Consistency Assessment Approval Form – Change to the location of the traction substation and construction footprint at Barangaroo Station

Planning approval reference details (Application/Document No. (including modifications)): SSI-15_7400 Sydney Metro City & Southwest – Chatswood to Sydenham

Figure 1: Proposed new location of the traction substation [Note: this is a basement/plant level plan as the substation is located fully underground and would not be visible from above ground. Only the northern station entry would be visible aboveground]

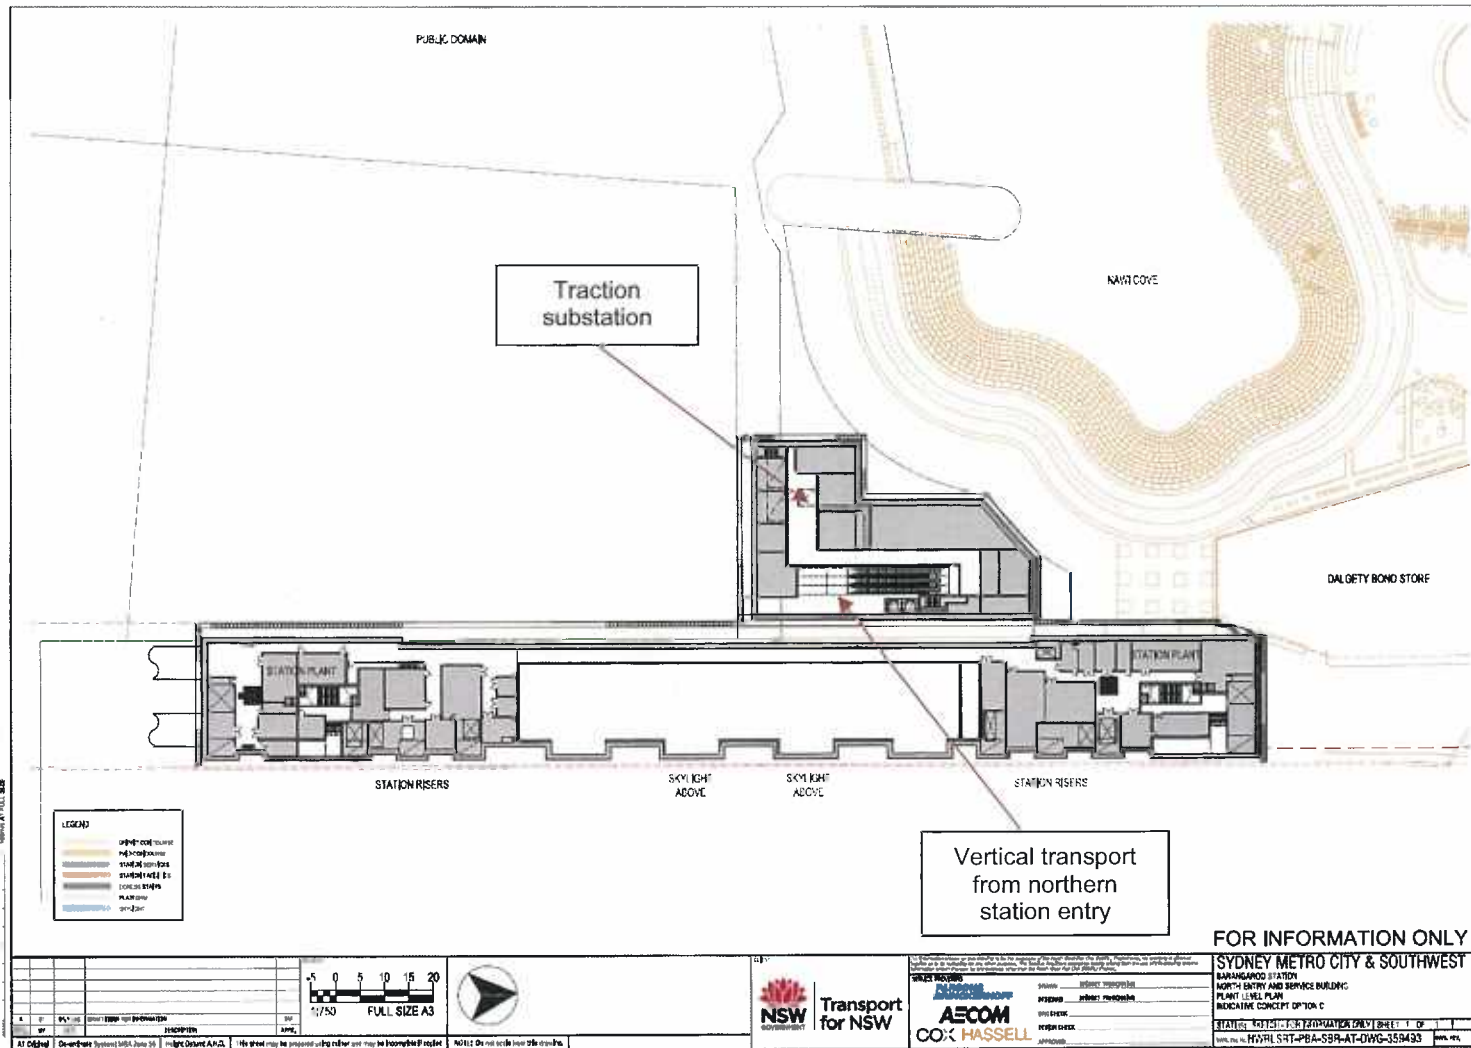
- The location of the traction substation would be moved to be integrated with, and located wholly underground, adjacent to the northern station entry. Refer to Figure 1 of the proposed location of the traction substation.
- The construction footprint for Barangaroo Station would be altered to support the new location of the traction substation and to ensure barging of spoil from the construction site minimise impacts on the staging of the Central Barangaroo development. Refer to Figure 2 for revised indicative layout of the Barangaroo Station construction site for the north entry and barging activities. The location of the haul and conveyor to the spoil barge will be located within this area. The construction site to the south at the approved location for the traction substation will no longer be required.

The approved traction substation location was partly underground and required some excavation. The proposed new traction substation location is wholly underground and therefore the depth of excavation would be greater and would generate additional spoil. The proposed underground location of the traction substation would require a cooling system to be installed. There are a number of options available for cooling, including connections to cooling system infrastructure being delivered by BDA. Identification of potential impacts and assessment of consistency of the final design of the substation cooling system would be undertaken as the detailed design is developed.

Figure 2: Revised indicative layout of the Barangaroo Station construction site for north entry and barging activities

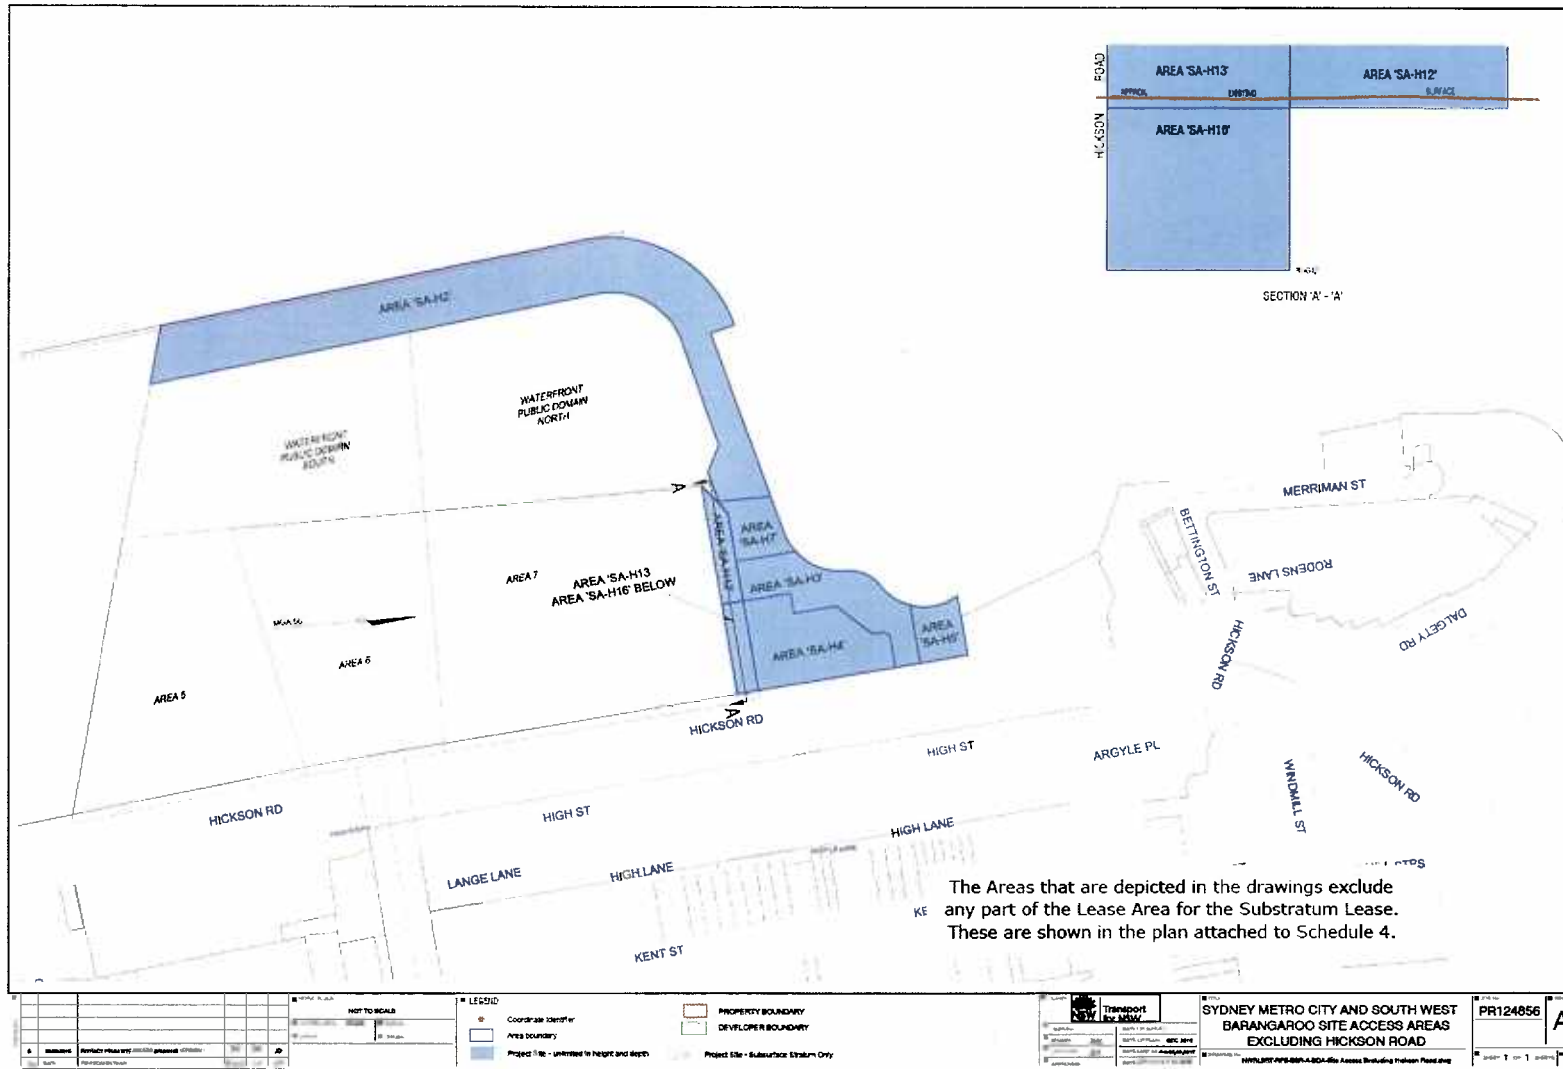
The scope and methodology of the construction activities at Barangaroo Station has not changed, although the location of some of these activities has been moved. There would be no change to the duration of work, working hours, machinery or staffing levels.
